UNITED STATES PATENT AND TRADEMARK OFFICE

APPLICATION NO.	FILING DATE	FIRST NAMED INVENTOR	ATTORNEY DOCKET NO.	CONFIRMATION NO.
09/627,637	07/28/2000	Kenichi Oinoue	P/3541-6	2855

Office Action Summary

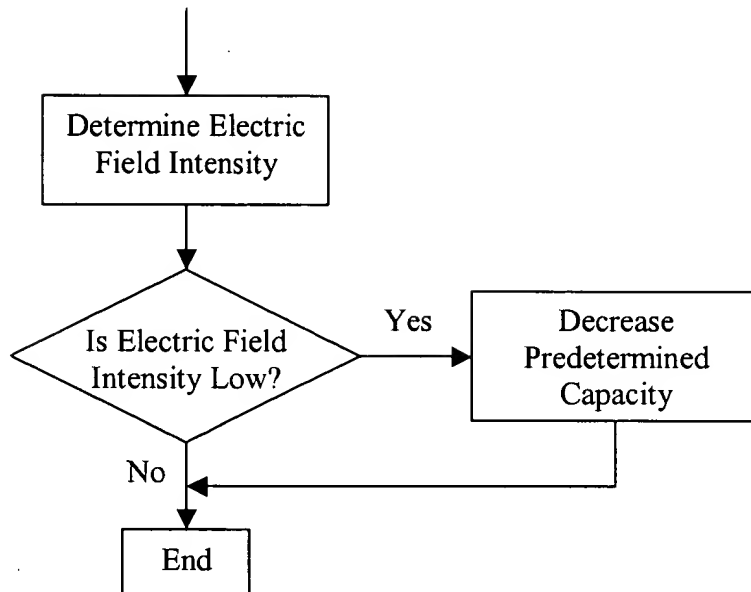
Should Applicant adopt Examiner’s suggestions with regards to the claims, the Examiner further suggests that the Applicant add a further figure so as to show the limitations above. The Examiner suggests submitting a flow chart similar to the one illustrated bellow.

In order to overcome this rejection the Examiner suggests amending claim 9 to read “said transmission control means includes judgment means to judge the capability of transmitting the recorded information to a nearest communication base station, and said setting means decreases the set memory capacity when said judgment means judges that there is a low capability to transmit the recorded information.” Examiner suggests similar amendments to claims 10 and 17-20.
